# Service Bulletin

**Product Line:** Snowmobile

**Bulletin No:** 2006-1-01

**Subject:** Gas Tank Neck Extension

Fig. 1

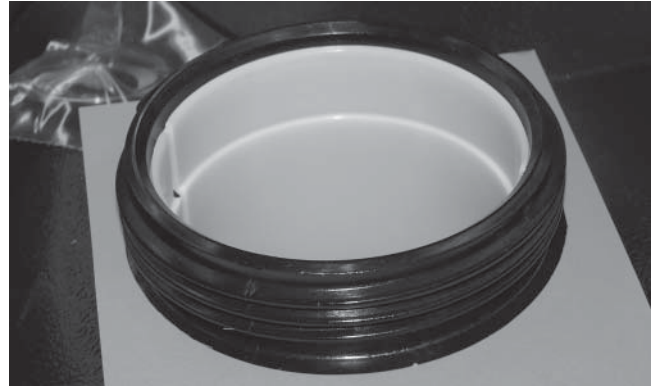
1. Remove the gas tank cap; then insert Gas Tank Neck Extension (p/n 1670-801) into the gas tank neck by carefully pushing it downward until it is seated. See Fig. 1 and Fig. 2.

■ **NOTE:** Push the extension into the gas tank neck by hand only. Do not use a hammer or any other tool. When seated into the gas tank neck, the top of the extension should be approximately 1/8 in. below the top edge of the gas tank neck.
